CHANGE ORDER NUMBER: 3

Project: 1603-062
Roadway: CR 258
CSJ Number: _____

CR 258

Change Order No. 3

ADDITION OF MOSNER'S DRIVEWAY

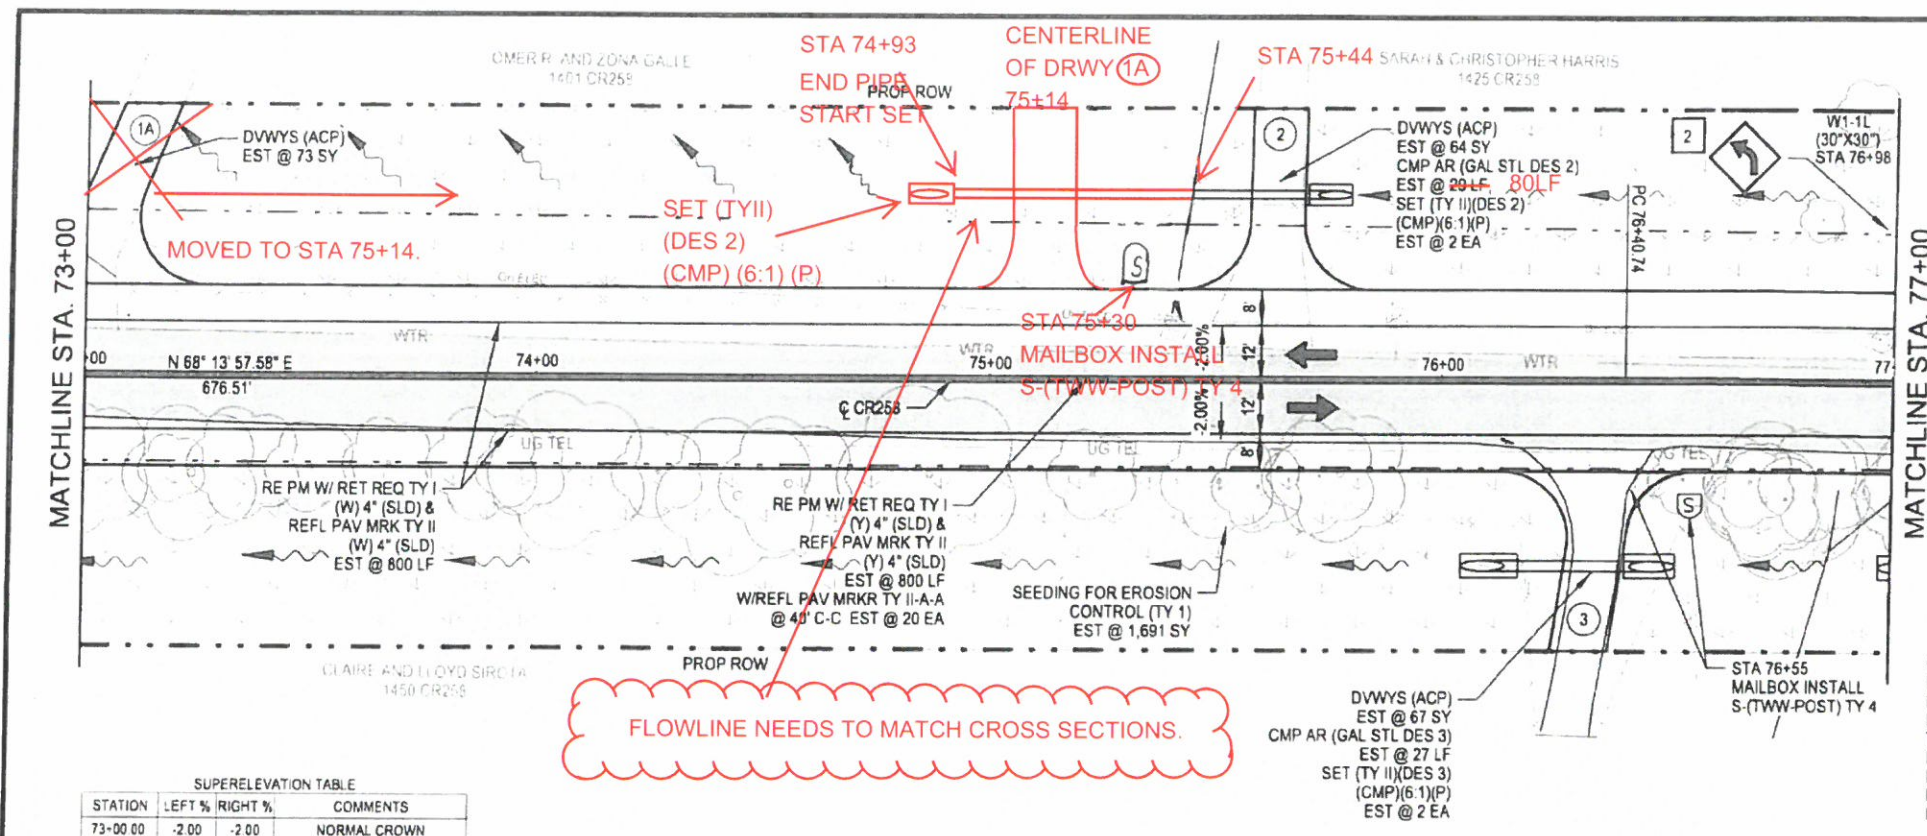
An adjacent property owner (Mr. Mosner) requested construction of a new driveway to his property that was not shown in the bid plans. The landowner received a permit from the County, just prior to the beginning of construction, approving Driveway 25A located at Station 147+60. The construction of the driveway includes, culvert pipes, safety end treatments and metal beam guard rail along the driveway radii. This is the property owner's only access to his property.

RECONSTRUCTION OF COUNTY ROAD 258
CR 258
PLAN AND PROFILE
STA. 73+00 TO STA. 77+00
SHEET 2 OF 24

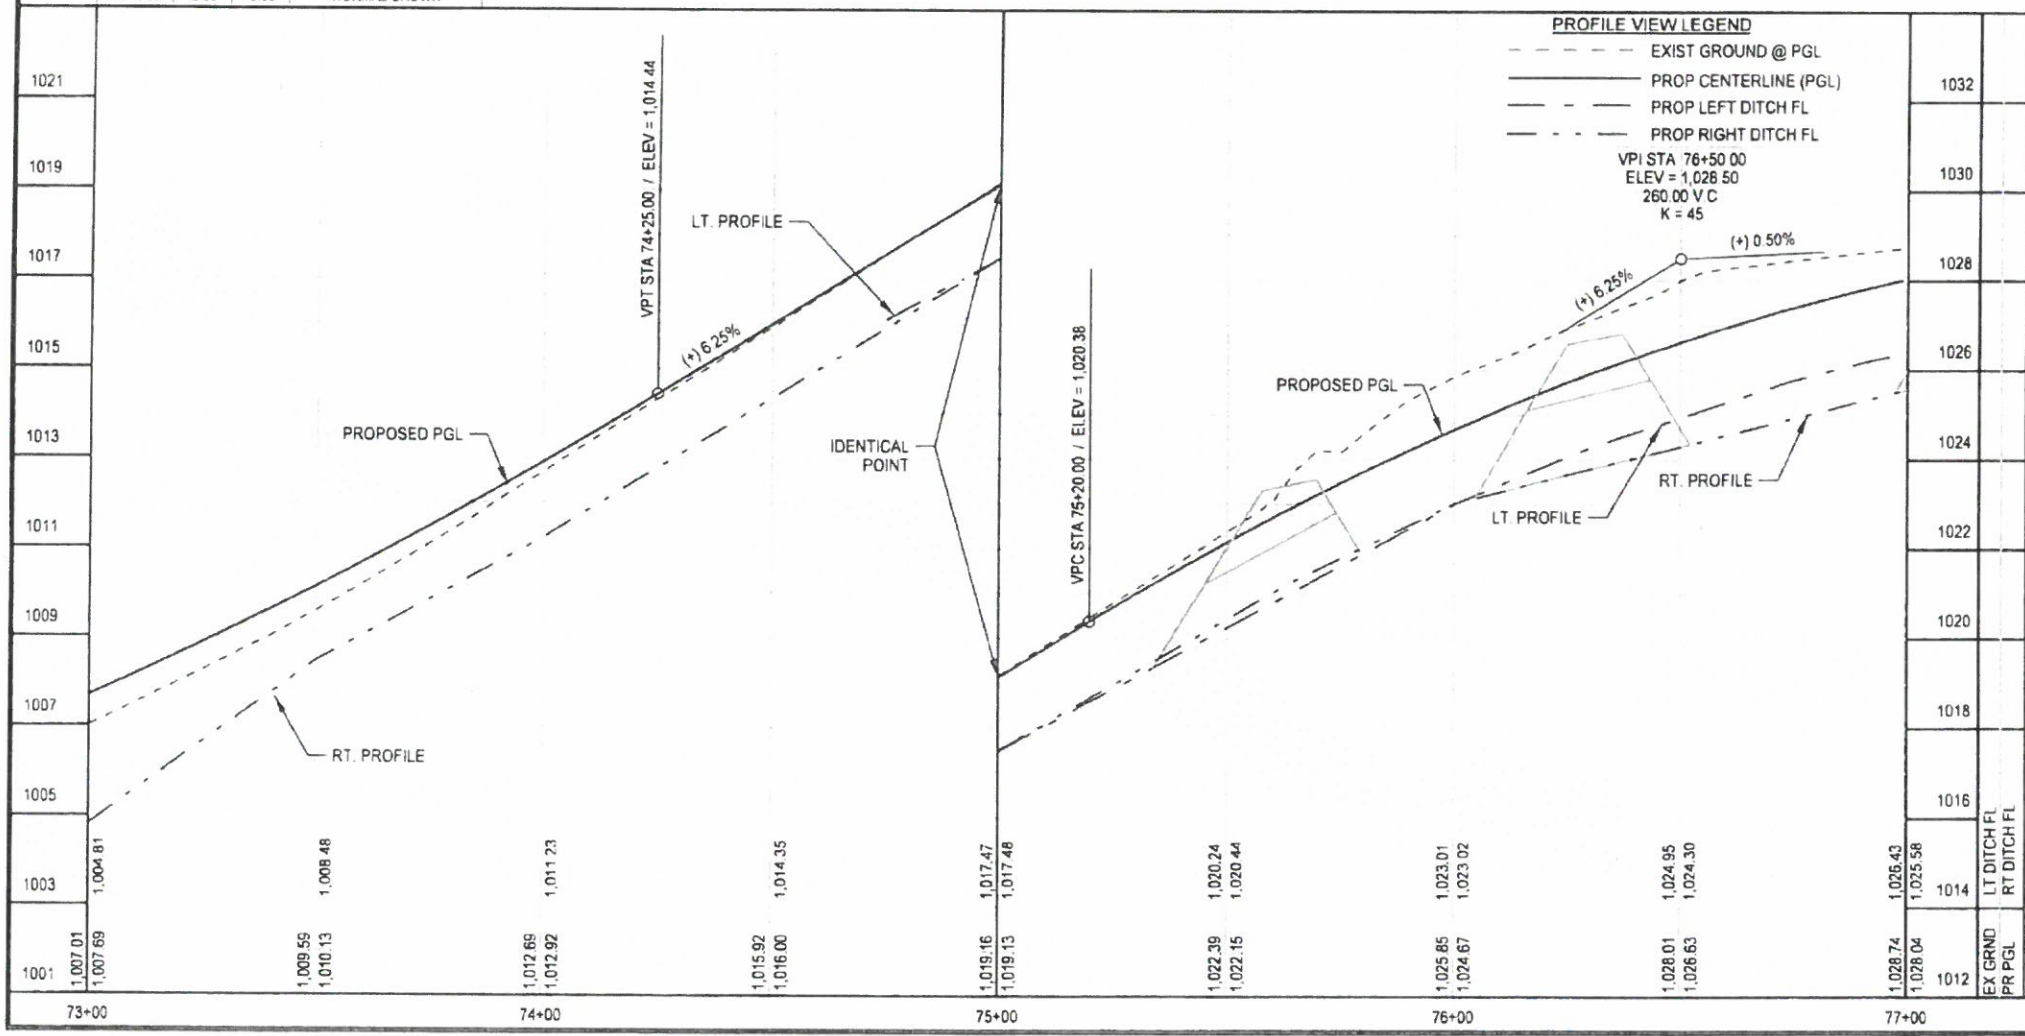
Driveway 1A, at approximate Station 73+00, was relocated to Station 75+14 at the request of the property owner. The driveway culvert pipe was extended to the west approximately 51 feet from Driveway 2, to accommodate the new location for Driveway 1A.

AS-BUILT SHEET, NOT TO SCALE.
CAN BE ADJUSTED IN THE FIELD
IF NECESSARY.

RECONSTRUCTION OF COUNTY ROAD 258
CR 258
PLAN AND PROFILE
STA. 77+00 TO STA. 81+00
SHEET 3 OF 24

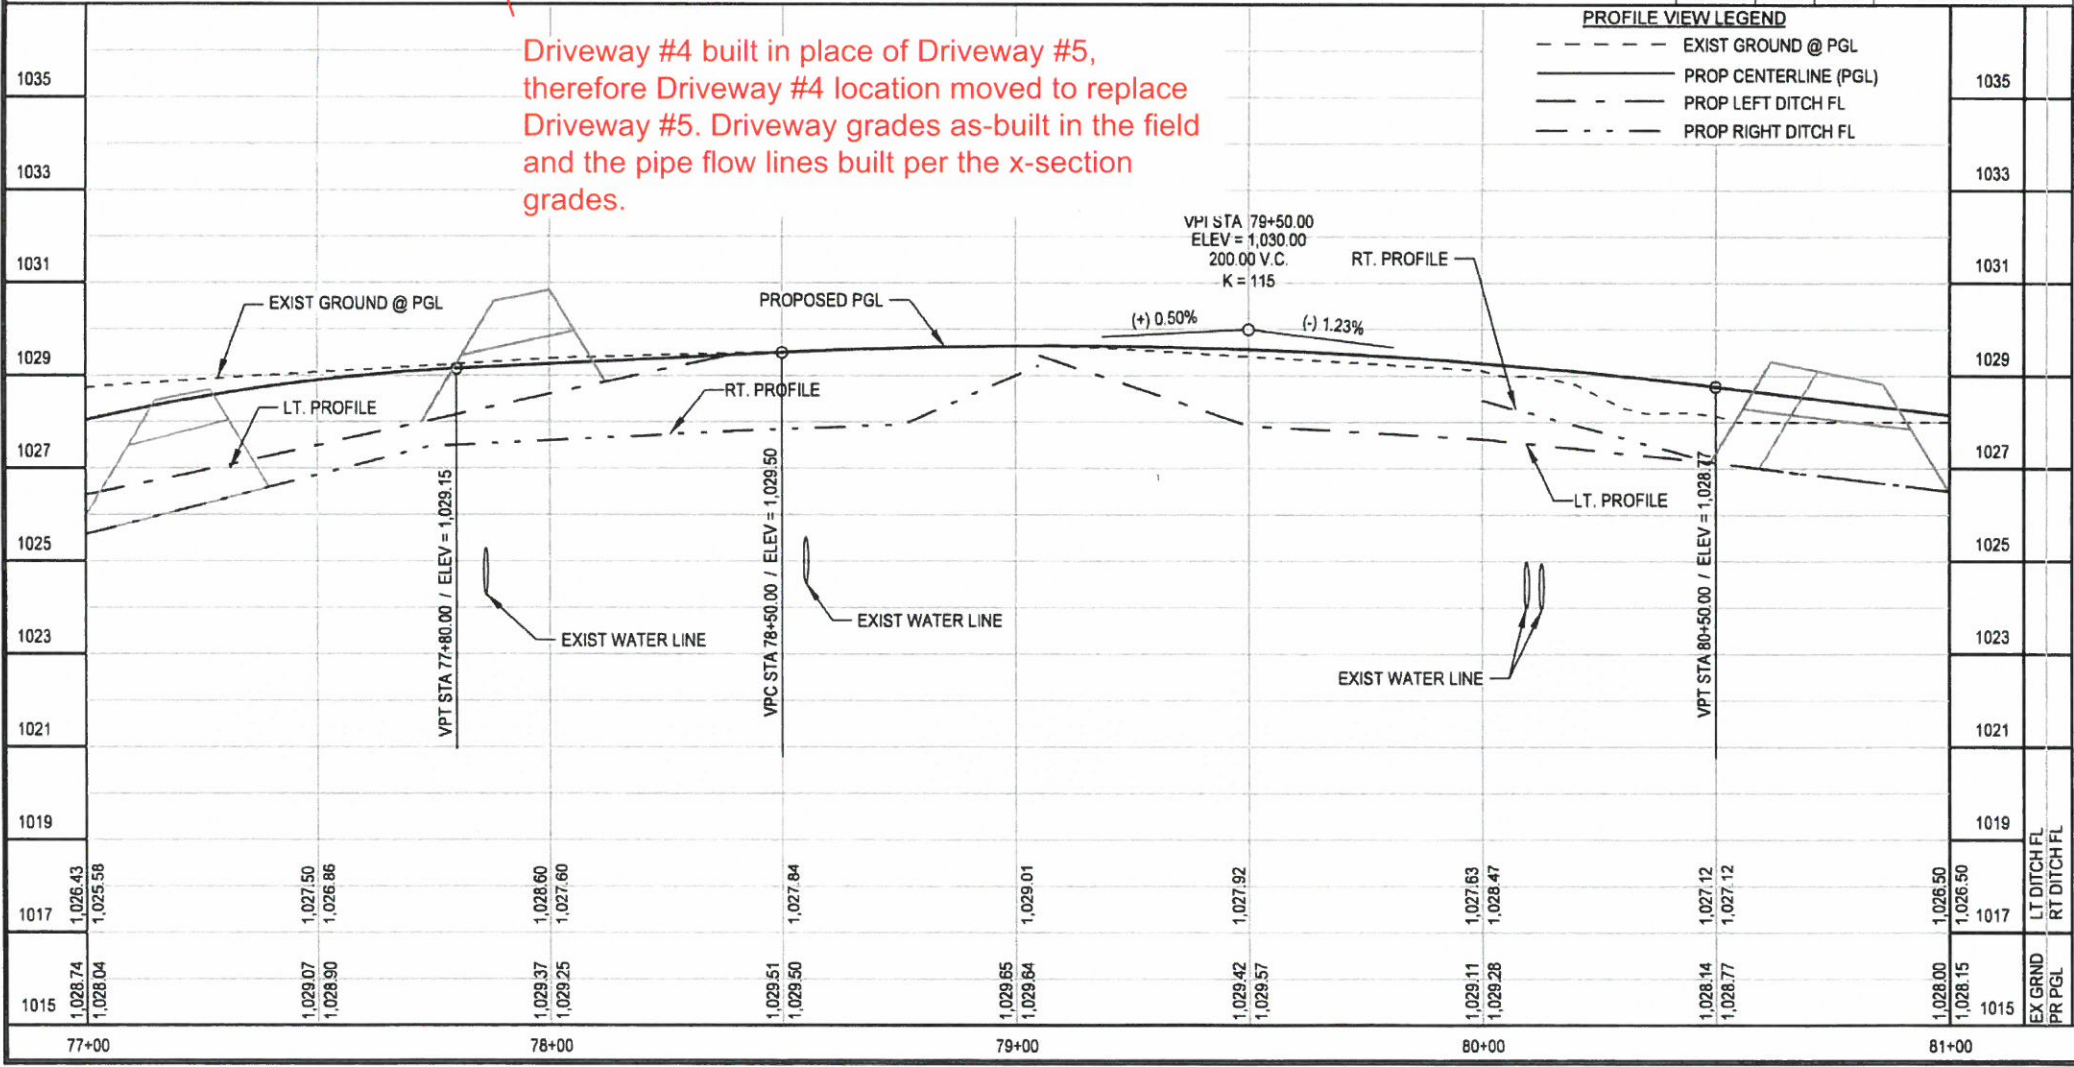
Per the plans, proposed Driveway 4 (Sta. 77+25) is a new asphalt driveway and Driveway 5 (Sta. 77+75) is an existing concrete driveway to be removed. Due to existing conditions and landowner access needs, Driveway 5 was removed and Driveway 4 was moved to the same station and built as concrete.

Driveway #4 built in place of Driveway #5, therefore Driveway #4 location moved to replace Driveway #5. Driveway grades as-built in the field and the pipe flow lines built per the x-section grades.

RECONSTRUCTION OF COUNTY ROAD 258
CR 258
PLAN AND PROFILE
STA. 149+00 TO STA. 153+00
SHEET 21 OF 24

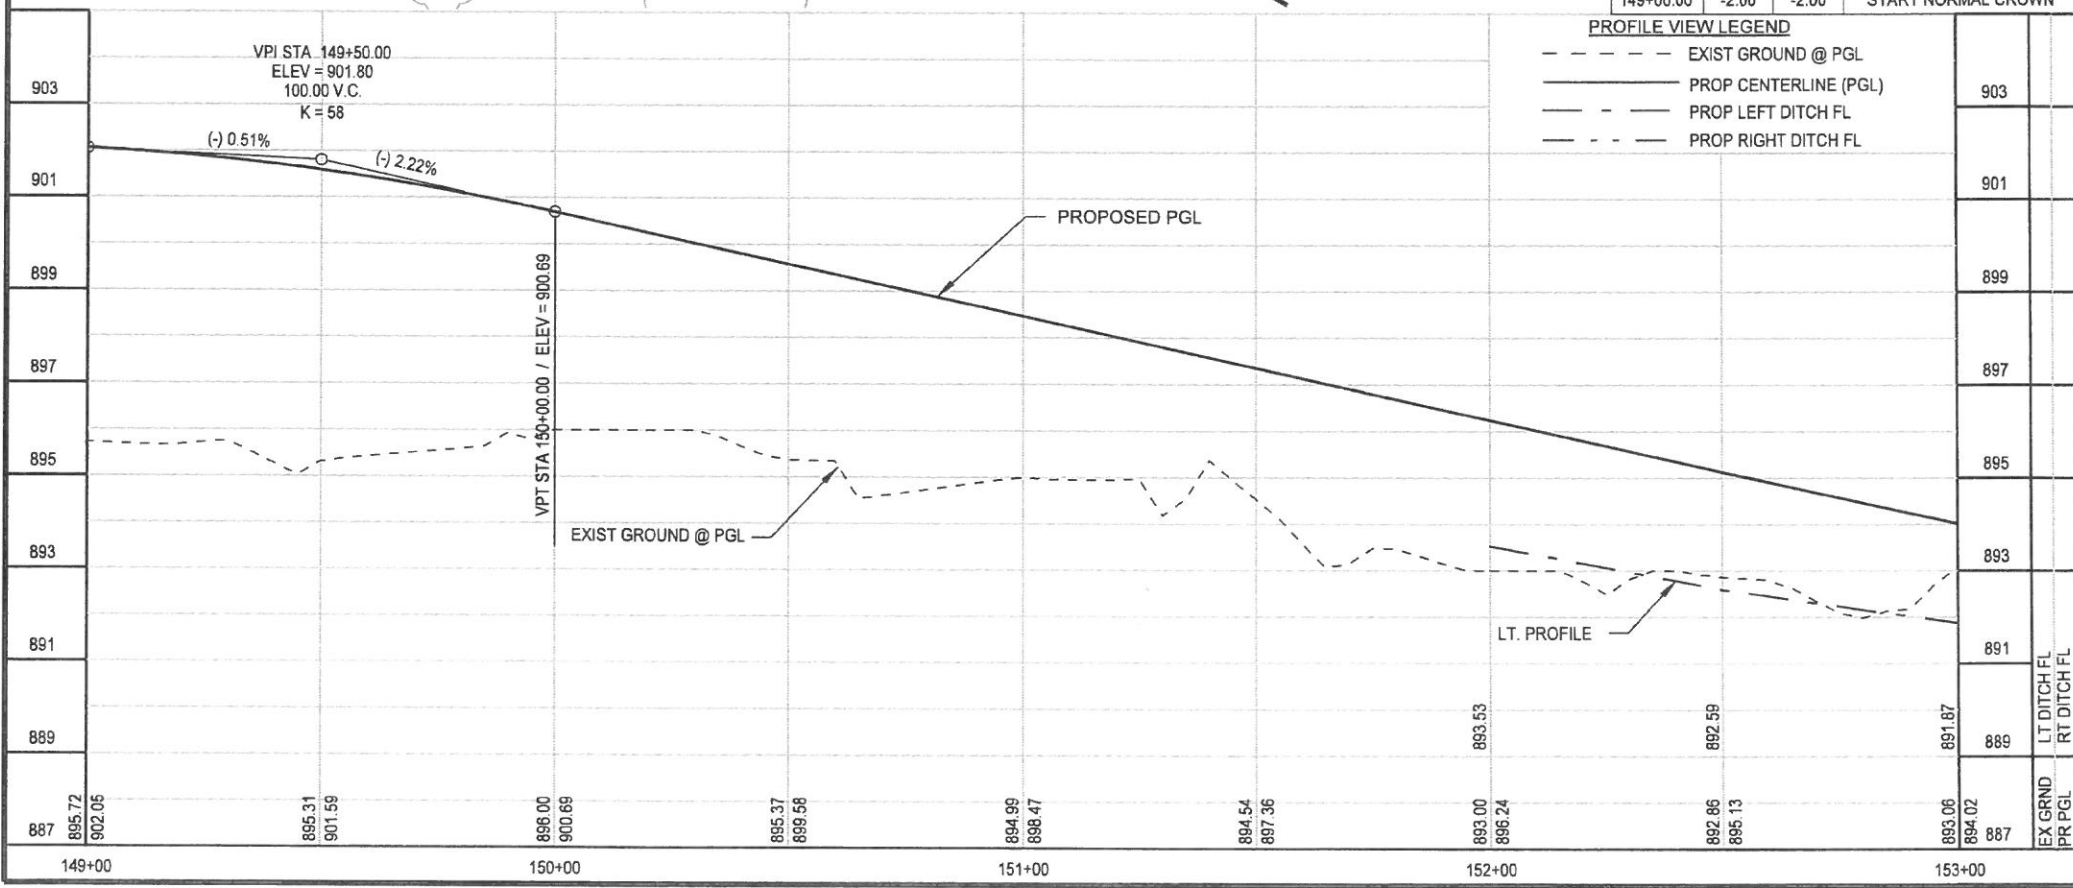
Proposed MBGF was shortened at Driveway 26, to keep the proposed guardrail (MBGF) within the ROW limits like Driveway 25A.

ADJUSTMENT TO MBGF AT DRIVEWAY 26.

"DRIVEWAY" TERMINAL ANCHOR SECTION

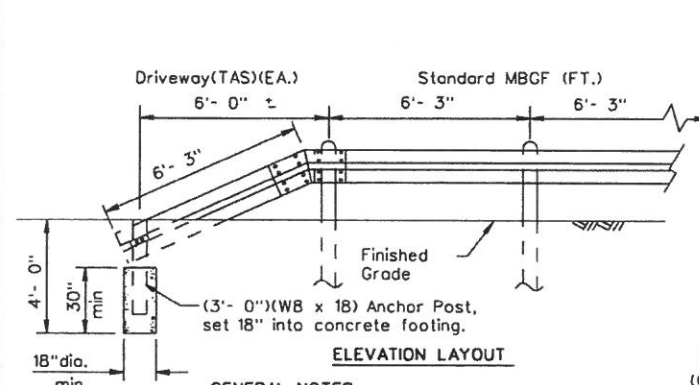
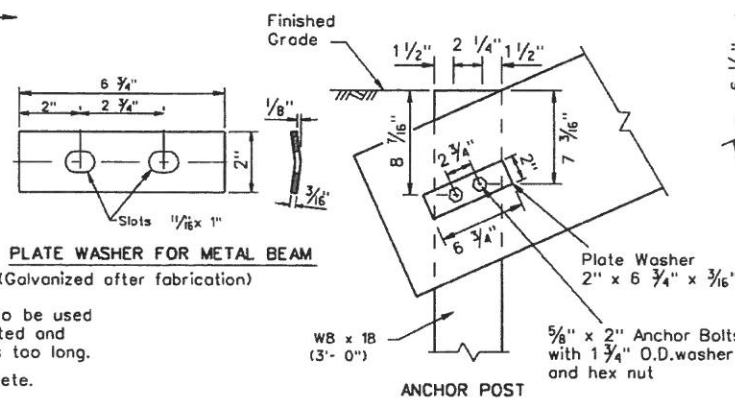
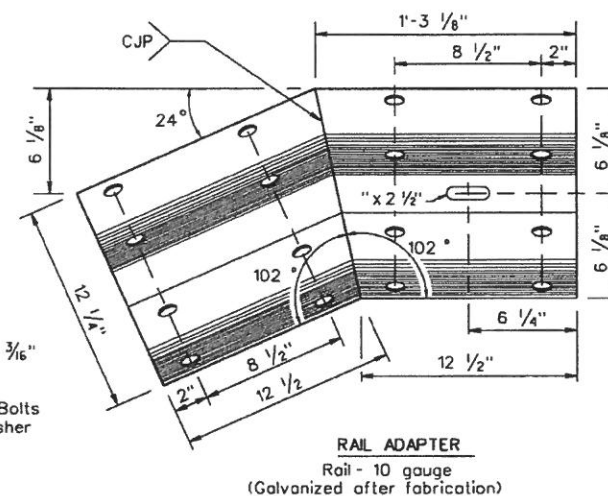
▲ STANDARD ADDED TO THE PLANS.

1. The "Driveway" Terminal Anchor Section is ONLY to be used within driveway locations, where the ROW is limited and a standard 25 ft. (TAS) Terminal Anchor Section is too long.
2. Terminal anchor post shall be set in Class A concrete.
3. All steel shall be galvanized after fabrication in accordance with Item 445, "Galvanizing."

Only for use within driveway locations, where a standard (TAS) Terminal Anchor Section can not be installed.
